UNITED STATES PATENT AND TRADEMARK OFFICE

10/579,770

Office Action Summary	Application No. 10/579,770	Applicant(s) KAERN ET AL.	
	Examiner ILYA Y. TREYGER	Art Unit 3761

DETAILED ACTION

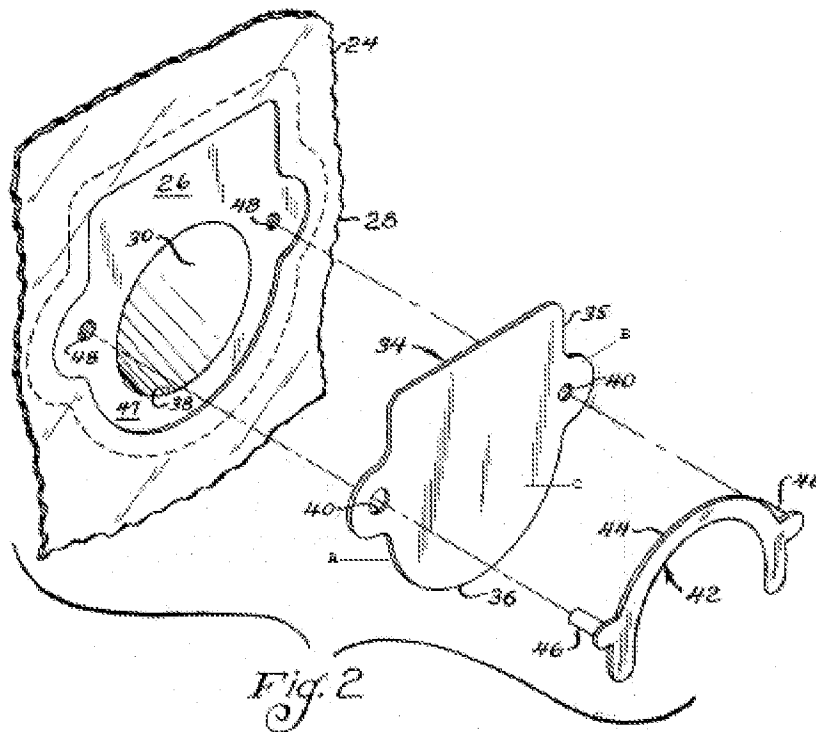
7. In Re claim 1, Boedecker discloses an anti-reflux device (Abstract, line 1) comprising: a wall 28 (Fig. 2) providing a drip chamber 26 (Fig. 2) which is a valve seat, and a valve element 34 (Fig. 2) defining an outer contour A (Fig. 2) formed from a sheet-shaped material, said valve element including a connection portion B (Fig. 2) and a flap portion C (Fig. 2) defining a longitudinal direction extending between the connecting portion and the flap portion, and bores 48 (Fig. 2) which are retaining means for retaining the valve element 34 with respect to the device, said retaining means being integral with the device. The connecting portion B includes apertures 40 (Fig. 2) which are engagement means formed integrally with the valve element for engagement with the retaining means, wherein the valve element is projecting a coherent plane (See Col. 2, lines 46-51, 64; Col. 3, lines 7-13).

9. In Re claims 6, 7, and 9, Boedecker discloses a device in which said outer contour A forms a curve defining a continuously advancing function on a respective side of the longitudinal direction (claim 6), and wherein the engagement means 40 are formed within (claim 7) and integrally (claim 9) in said outer contour (claim 7) (See Fig. 2).

In Re claim 12, Boedecker discloses the valve element 34 (Fig. 2) including at least one connecting portion B (Fig. 2) and a flap portion C (Fig. 2) and defining a longitudinal direction

extending between the connecting portion and the flap portion, and with engagement means 40 (Fig. 2) integrally formed in the valve element (Col. 2, lines 46-51, 64; Col. 3, lines 7-13).

Fig.

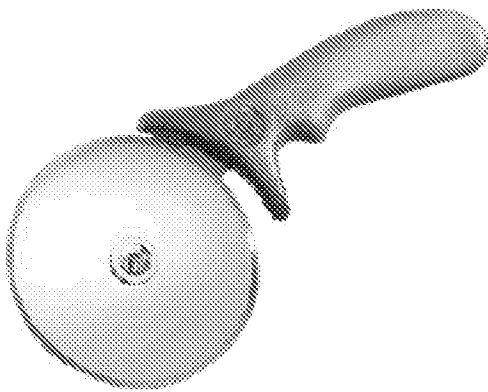
15. In Re claim 18, Boedecker discloses the claimed invention except for the method in which the cutting operation is performed in a rolling operation. It would have been obvious to one having ordinary skill in the art at the time the invention was made to perform the cutting operation in the rolling operation. Examiner takes an Official Notice that the the rolling operation has been conventionally used in the cutting process (See Fig.).

FIG.2

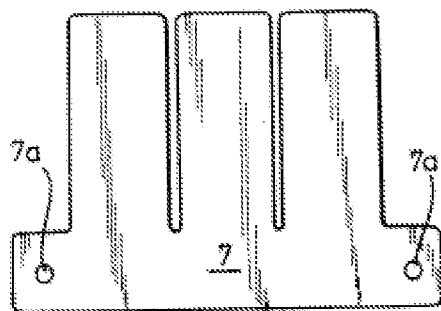
Morone teaches the flap valve wherein the valve element is slit- or incision-shaped (since the incision is a variation of slit) (See Fig. 2).

It would have been obvious to one having ordinary skill in the art at the time the invention was made to make the valve element of Boedecker slit- or incision-shaped, as taught by Morone in order to improve valve element fixation.
